**CHC Associates Pty Ltd**

# Report to the Australian Energy Regulator

## Review of Conversion of Braemar – Kogan Creek Line Assets

16 September, 2011

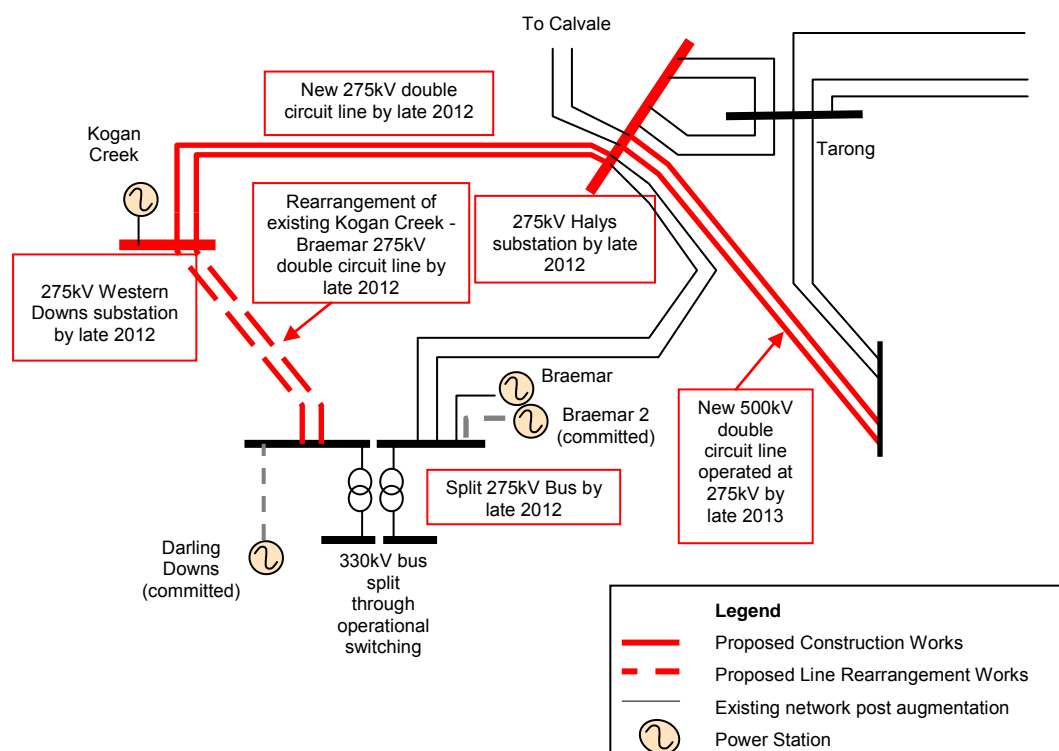
The plan described in the Application Notice and Final Report calls for the Braemar substation to be split into two sections: West and East, each comprising a 330kV and 275kV busbar connected through a transformer, and with the generating capacity shared between these two halves. This requires that the substation be arranged so that the halves can be separated by opening circuit breakers on both the 330 kV and 275 kV sides. The transmission circuits in and out of the substation will come together

This means that generators connected to Braemar West will make a reduced contribution to a fault at Braemar East and vice versa, so that the fault level on both sides is reduced. The diagram provided by PLQ in the Final Report is copied below for convenient reference.

In the plan outlined in the Application Notice the Kogan Creek generator remained connected to Braemar West, whereas in the Final Report it is connected to Western Downs, at which location other yet-to-be-announced generators could be connected with slightly less impact on the Braemar West fault level.
